2014 ANNUAL MONITORING AND MAINTENANCE REPORT

Ross Island Sand & Gravel Company
Portland, Oregon

Revised December 2014

Annual Monitoring and Maintenance Report

FIGURE 16
2014 vs. 2013 Loss Analysis

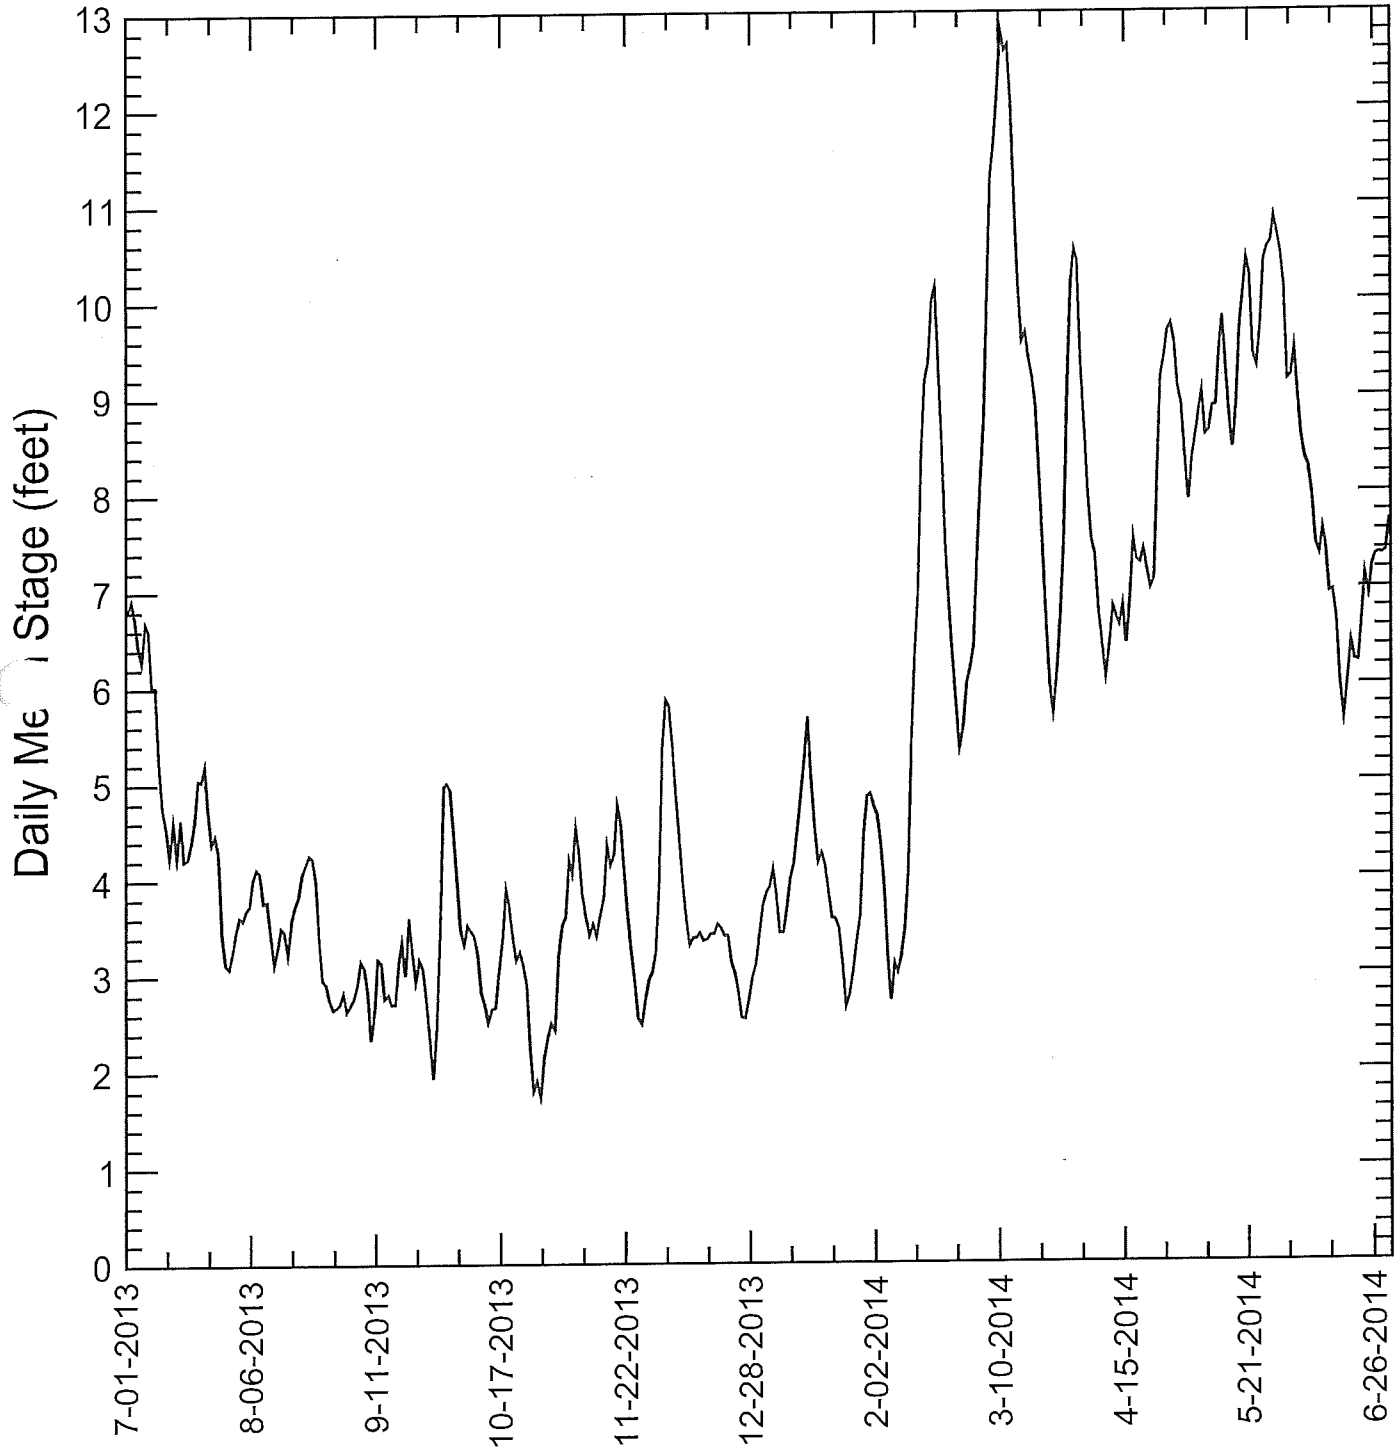
Response to review comment number 2 from DEQ letter dated November 13, 2014.

Scattered spots of loss of 0.5 feet or less and less frequent areas of loss of 0.5 or greater are the result of settlement due to the ebb and flow of the tides in the lagoon, thus changing the underwater landscape. Figure 16 presents areas of loss greater than 2 feet between the 2013 and 2014 surveys. The maximum area (1,825 sq. ft.) and loss in elevation (8.8 feet) occurs near the northern boundary of the remedial action area. However, at this location, the thickness of the sediment cap is 34 feet and this area is located approximately 300 feet north from the nearest CAD Cell (see Cross Section B-B'). Additional fill was placed in this location on November 21, 2014.
